## ENVIRONMENTAL ASSESSMENT REPORT

### UTS CENTRAL, BROADWAY PRECINCT, CITY CAMPUS SSD 7382 MOD 1

**Figure 6: Proposed Level 5 Floor Plan** (source: SSD 7382 MOD 1 Statement of Environmental Effects)

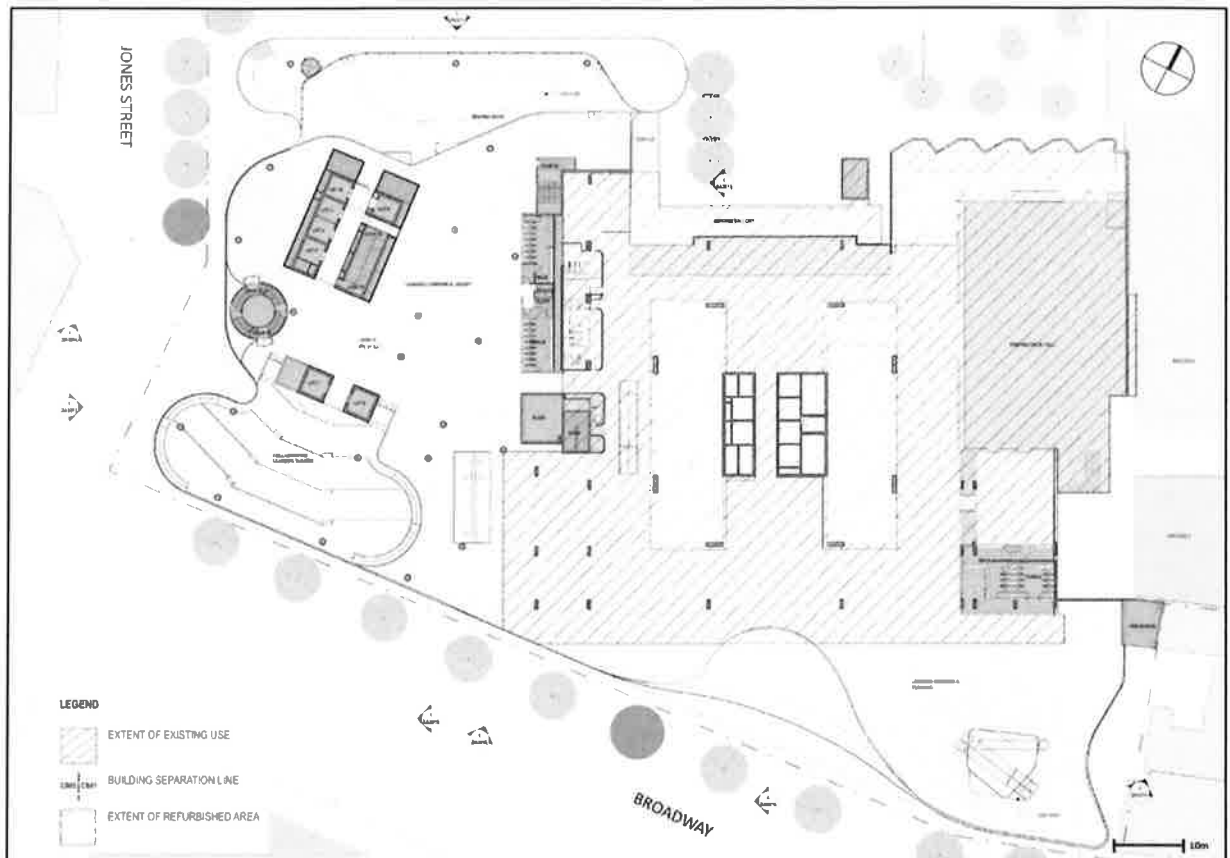
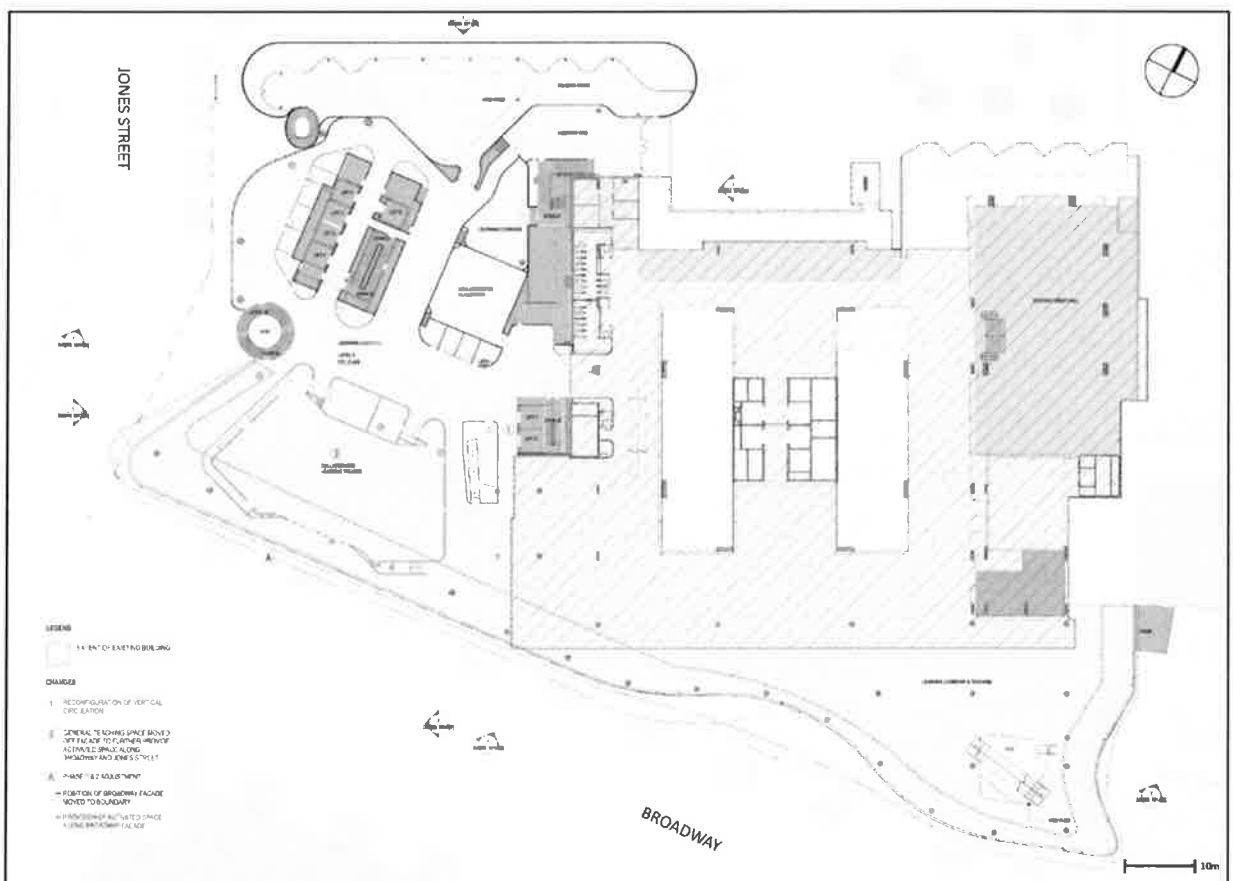
The Department notes that the proposed modifications are generally cosmetic changes and the overall height and bulk of the approved building remains largely unchanged except for the relocation of the southern façade of the podium Levels 5 to 7 by 1.5 metres to the site boundary along Broadway. The podium and tower buildings retain a good relationship and the building would continue to contribute positively to the Broadway streetscape. The building as modified continues to protect significant view corridors and has negligible impact on public domain views and no impact on private views.

Whilst the Department considered the location of the Collaborative Learning Theatres satisfactory in approving the development as teaching and learning would be 'on display', detaching the theatres from the façade would also provide a positive outcome to ensure activation of the southern façade and the transparent lightness of the façade is retained. Whilst the Department initially raised concerns regarding the width of the space between the theatres and the façade, the Applicant has demonstrated that the uses around the theatres would facilitate the activation of these areas and promote circulation.

**Figure 10: Proposed Broadway (south) Elevation** (source: SSD 7382 MOD 1 Statement of Environmental Effects)

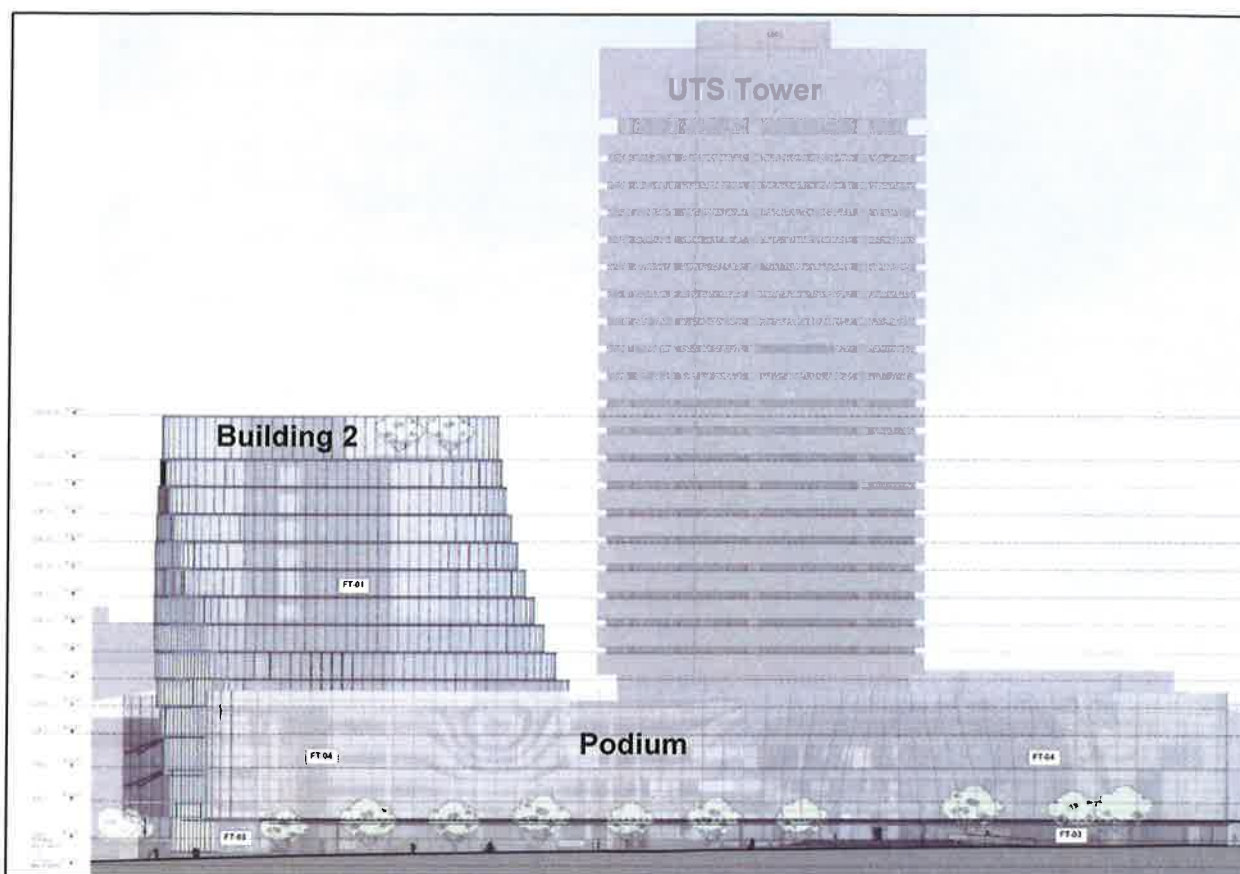
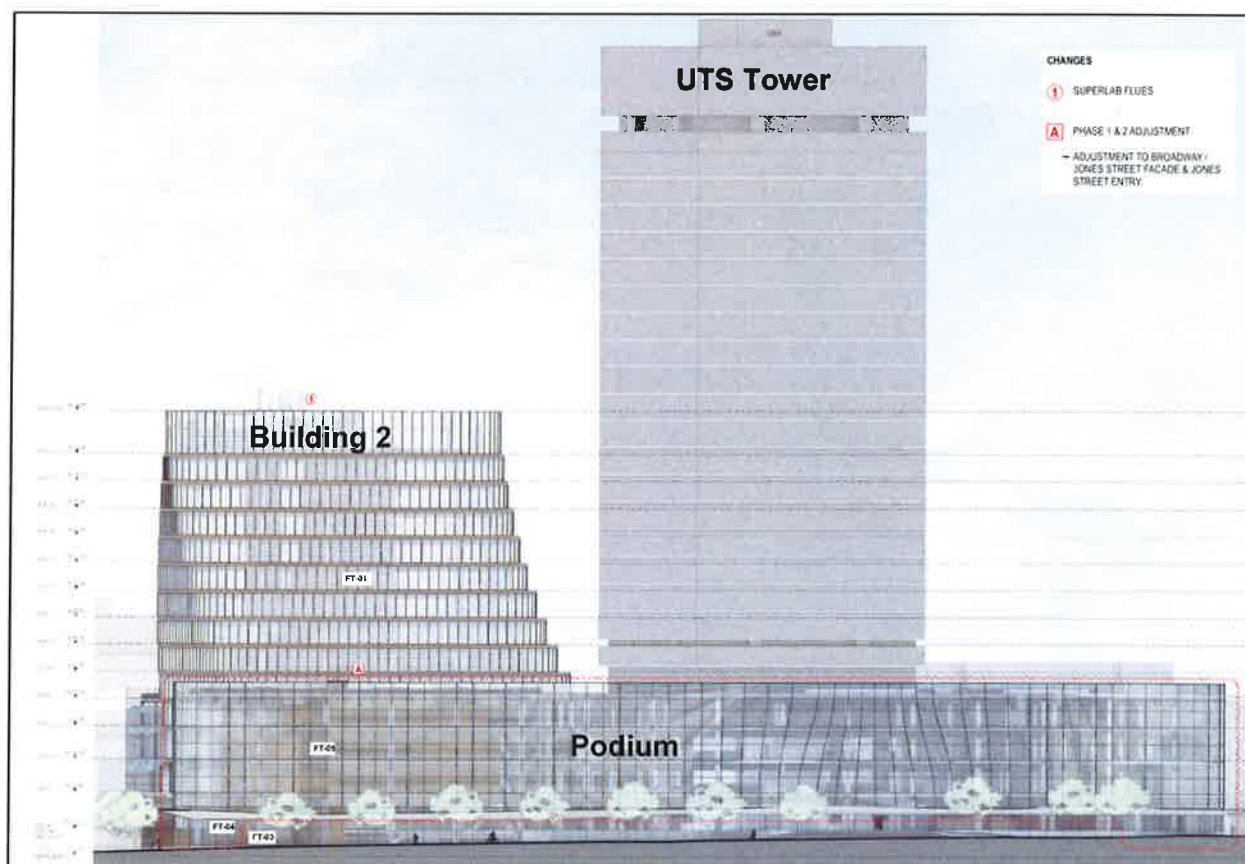
The Department in consultation with the NSW Government Architects office has reviewed the application and considers that the proposed modifications generally respond positively to concerns previously raised and requiring further design resolution. The most notable and externally visible change is to the curvature of the podium façade, as the curvature at the Jones Street intersection has been satisfactorily reinstated to represent the winning *Lacoste + Stevenson* design. Whilst the lightness and subtlety of curve of the modified design does not entirely achieve the fluid curvature of the *Lacoste + Stevenson* design, the positive changes are considered satisfactory.
